REHABILITATION OF SEVEN GRAND CENTRAL PARKWAY BRIDGES BETWEEN UNION TURNPIKE AND COMMONWEALTH BOULEVARD

PIN X051.59, Contract D900057

Addendum #7

May 2, 2023

CONTRACT NUMBER D900057 DRAWING NO. TBL-3

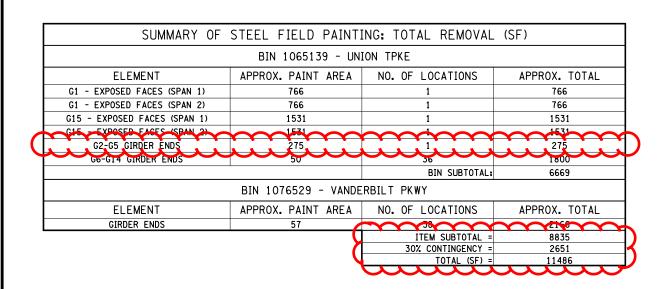
Delete Pages TBL-1, TBL-2, and TBL-3 of the RFP – Part 6 – RFP Plans, and substitute with the attached revised Pages TBL-1, TBL-2, and TBL-3.
